PETITION NO: Z-115
HEARING DATE (PC): 12-06-16
HEARING DATE (BOC): 12-20-16
PRESENT ZONING: O&I, R-20
PROPOSED ZONING: RM-8

PROPERTY LOCATION: Northwest side of Cooper Lake Road and the north and east sides of Daniel Street (2235 Cooper Lake Road and 2001 Daniel Street)

ZONING COMMENTS:

Z-115 BROOKS CHADWICK CAPITAL, LLC

SITE ANALYSIS

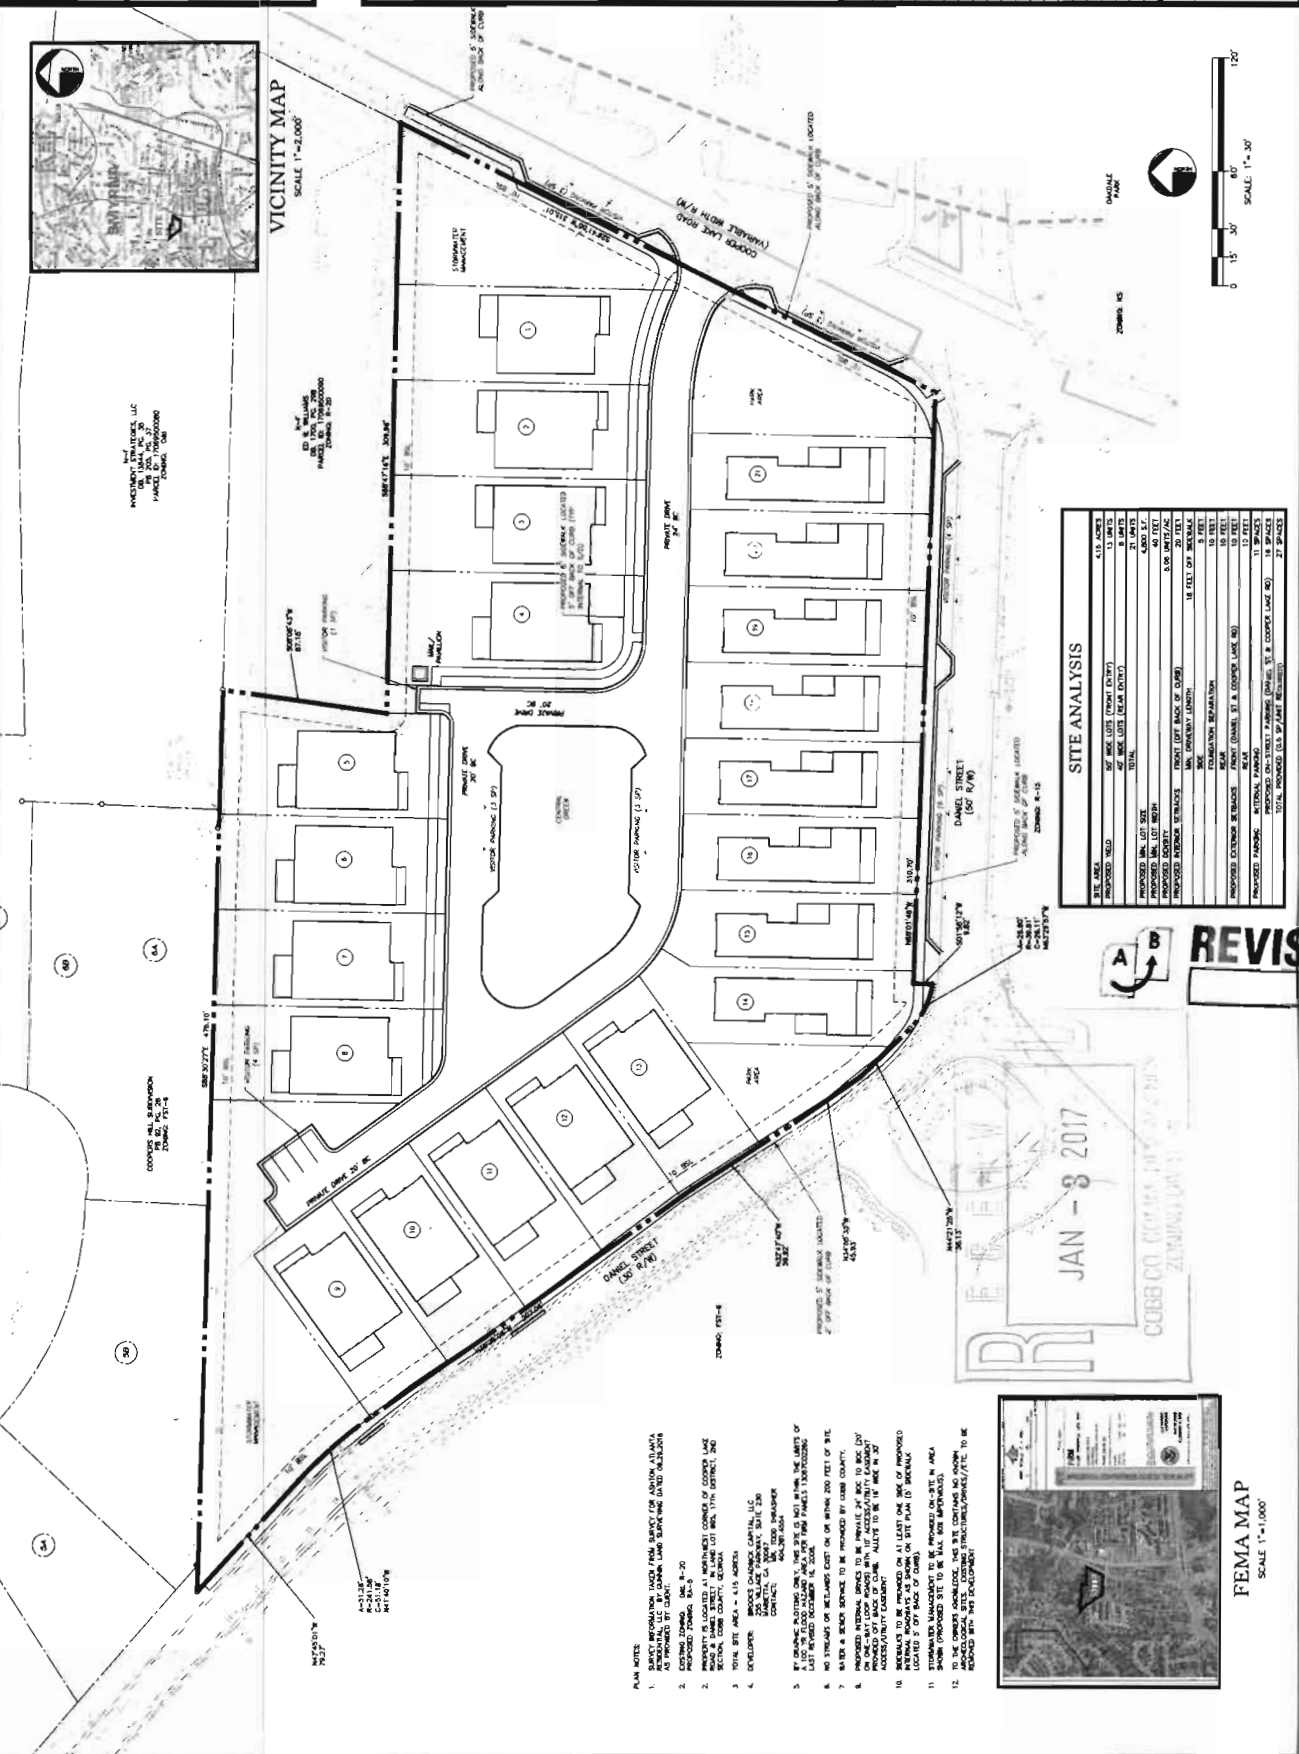
Additional Submitted site plan shows building Unit 1 encroaching upon existing sewer easement, which Comments: is a violation of Code 122-123..

- Provide comprehensive hydrology/stormwater controls to include development of out parcels.
- Submit all proposed site improvements to Plan Review.
- Any **spring activity** uncovered must be addressed by a qualified geotechnical engineer (PE).
- Structural fill _____ must be placed under the direction of a qualified registered Georgia geotechnical engineer (PE).
- Existing facility.
- Project must comply with the Water Quality requirements of the CWA-NPDES-NPS Permit and County Water Quality Ordinance.
- Water Quality/Quantity contributions of the existing lake/pond on site must be continued as baseline conditions into proposed project.
- Calculate and provide % impervious of project site.
- Revisit design; reduce pavement area to reduce runoff and pollution.

- No Stormwater controls shown _____
- Copy of survey is not current – Additional comments may be forthcoming when current site conditions are exposed.
- No site improvements showing on exhibit.
